Group:	17-Intake and Exhaust
Bulletin No.:	SB-15-016
Issue Date:	03-06-2015

TECHNICAL SERVICE BULLETIN

13MY-15MY COE J05 Broken Exhaust Manifold Studs

New parts are available to prevent repeat exhaust manifold stud failures on the J05 engine. This bulletin provides instructions for installing longer manifold studs at the #4 cylinder location.

Stud Locations

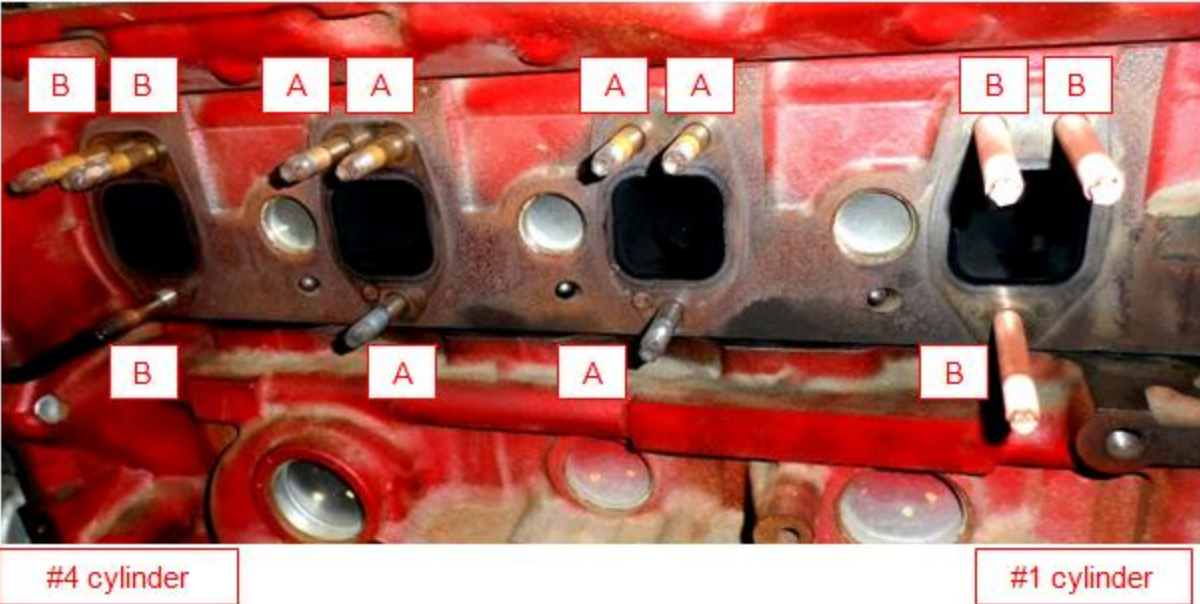
3. Install the new studs into the cylinder head as shown in the photograph below, referencing the table below for proper stud location. Tighten the studs to the specified torque..

Specified Torque: 22 lb-ft (30Nm)

NOTICE: Excessive torque on the exhaust manifold studs could cause the cylinder head to crack.

Location	Stud	
	Part Number	Length
A	SZ12610012	56 mm
B	SZ12610009	96 mm

Spacer Locations

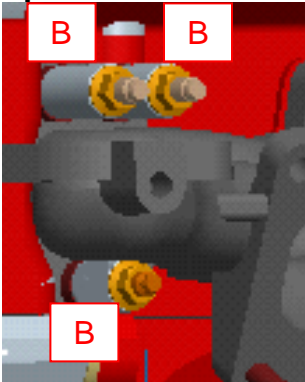
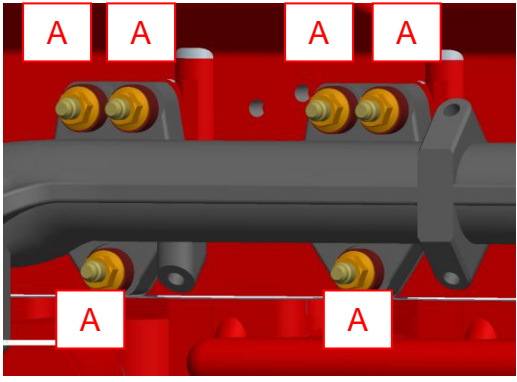
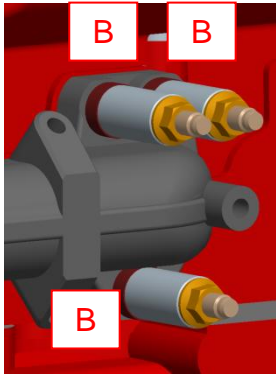
NOTICE: There are two different lengths of the spacers to be installed. Be sure to install each spacer in the correct location.

Install the spacers as shown in the illustration below. Refer to the table below for the part number of each spacer. Install the 14mm nut (SZ17810007) onto each of the studs, and tighten the nuts to the specified torque following the torque sequence outlined in the workshop manual. Once all 12 nuts have been torqued to specification, re-torque them again in the same sequence.

Specified Torque: 43.5 lb-ft (59 Nm)

NOTICE: Make sure that the spacer remains centered while tightening the nut.

Location	Spacer	
	Part Number	Length
A	SZ91016217	8 mm
B	SZ91016297	45 mm
